R. E. GINNA NUCLEAR POWER PLANT

AMENDMENT TO FACILITY OPERATING LICENSE

Amendment No. 22
License No. DPR-18

SAFETY EVALUATION BY THE OFFICE OF NUCLEAR REACTOR REGULATION
SUPPORTING AMENDMENT NO. 22 TO FACILITY OPERATING LICENSE NO. DPR-18

FIGURE 1

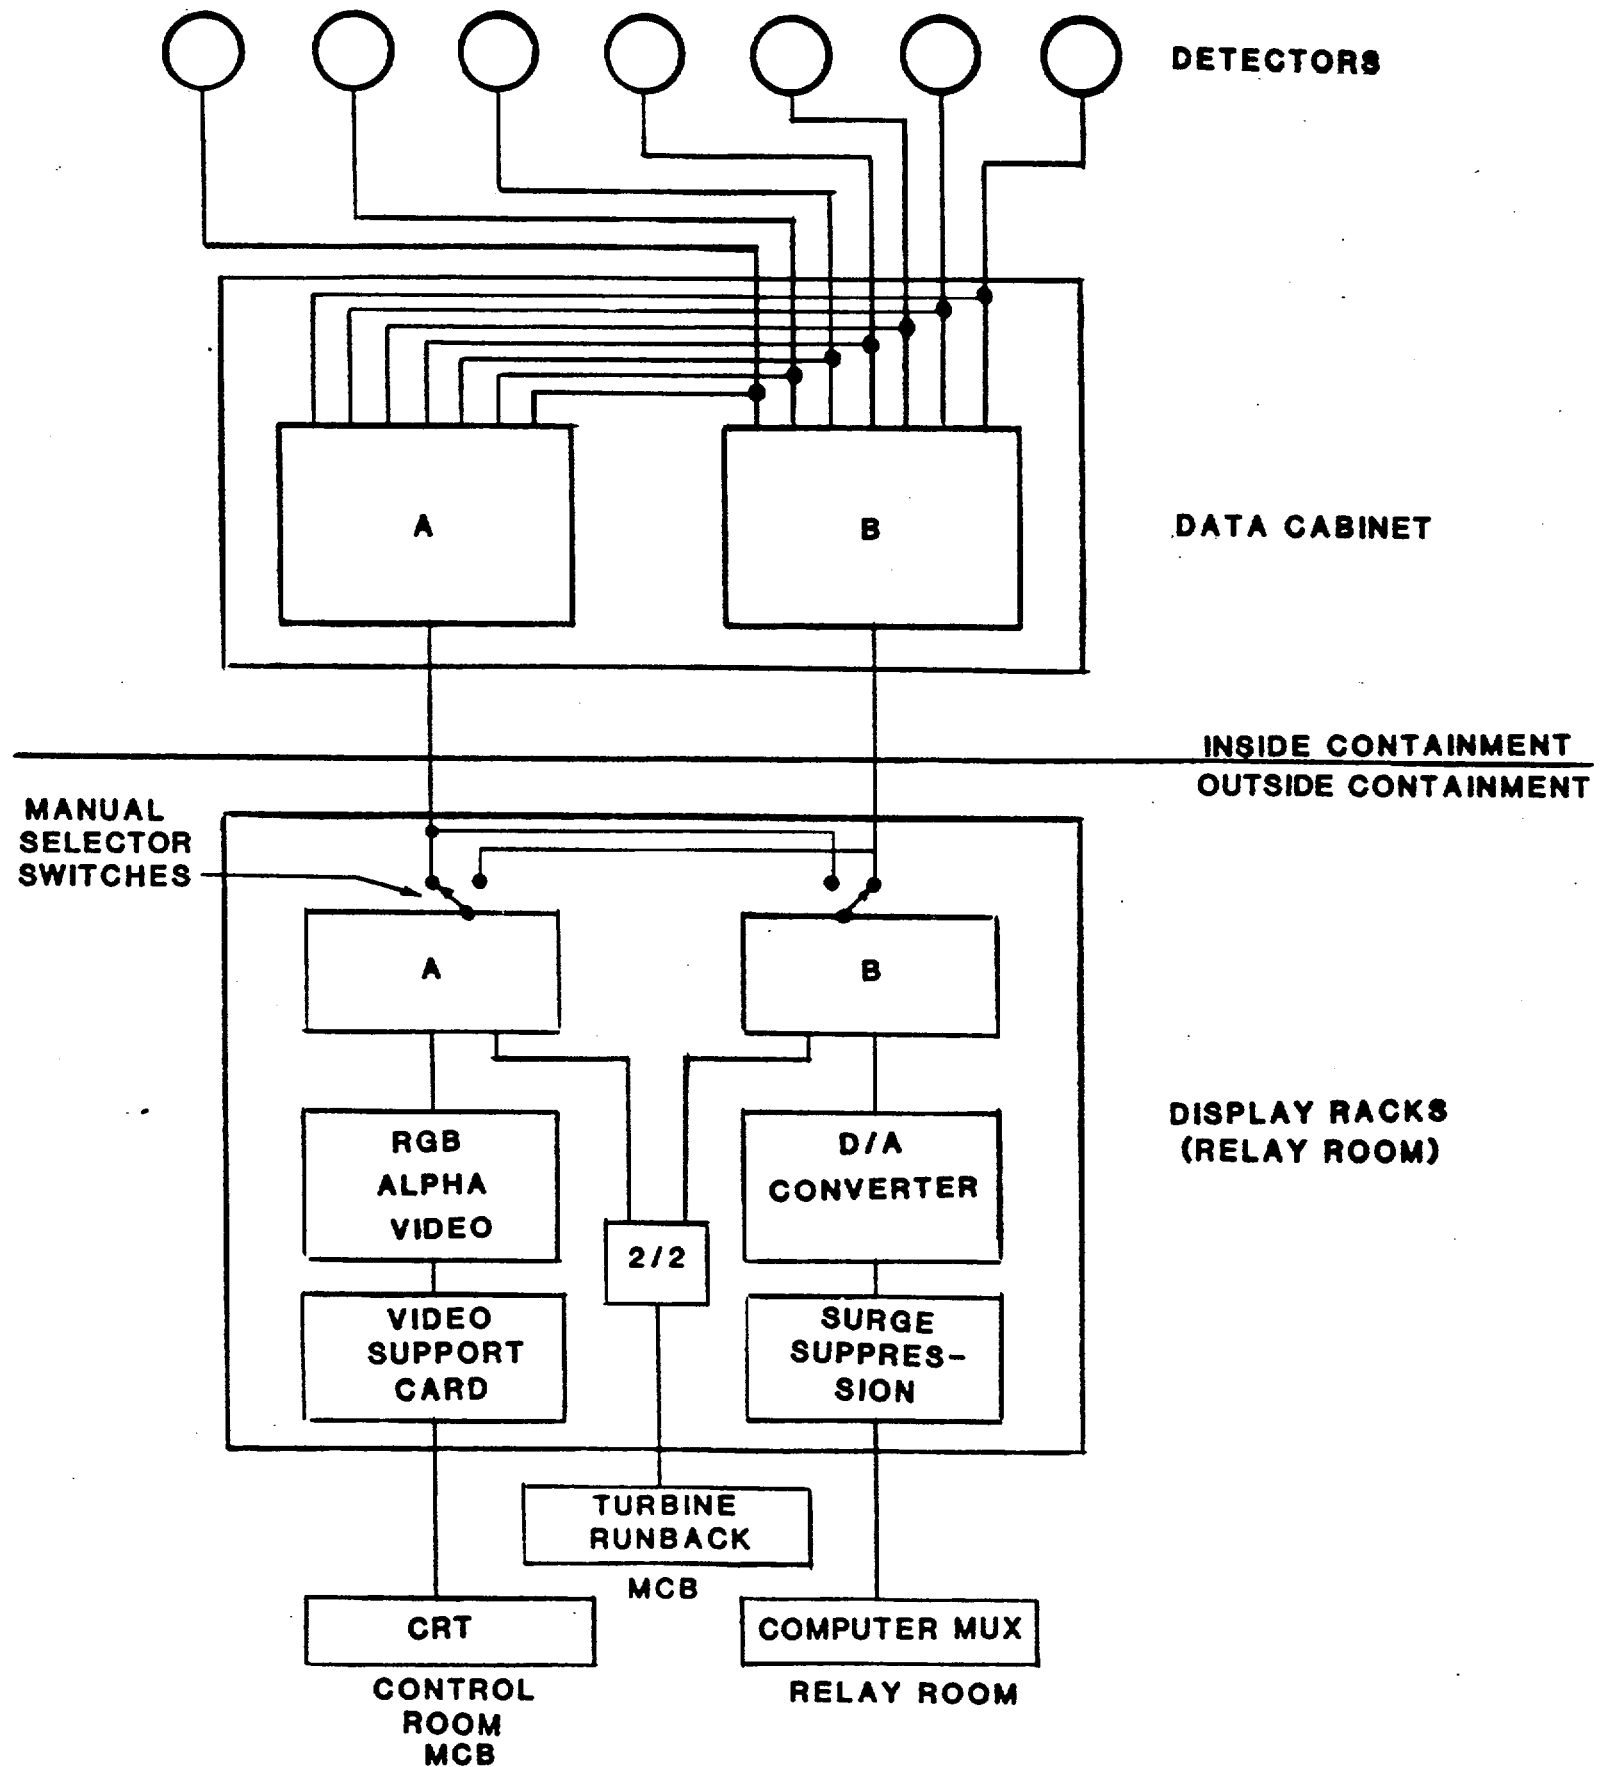
A block diagram of the MRPI system is illustrated in attached Figure 1. The system consists of a digital detector assembly for each rod, a data cabinet located inside containment, and display racks located in the relay room. Rod position data is displayed on a color cathode ray tube (CRT) in the control room and transmitted to the plant process computer system (PPCS). The data cabinet inside containment contains two multiplexers which take rod position information from each of the rods and transmit it to the processors which are in the display racks located in the relay room. One processor supplies information to the CRT located on the control board, the other processor supplies information to the PPCS. Both processors produce a turbine runback and block rod withdrawal signal.

The MRPI system senses rod position in intervals of 12 steps for each rod. The digital detector assemblies consist of 20 discrete coil pairs spaced at 12 step intervals for a series of 12 step ranges which automatically vary as the rod is moved beyond the range limits. The MRPI system will normally indicate 0 rod position until the rod goes from the fifth to sixth step. When the rod is positioned between the fifth and sixth step, the indication range will normally switch from 0 to 12. When the rod goes from the seventeenth to the eighteenth step, the indication will normally switch from 12 to 24. The rod will normally be within ± 6 steps of the MRPI indication, however, if the transition uncertainty of ± 2 steps is considered the rod will always be within ± 8 steps of the MRPI indication.
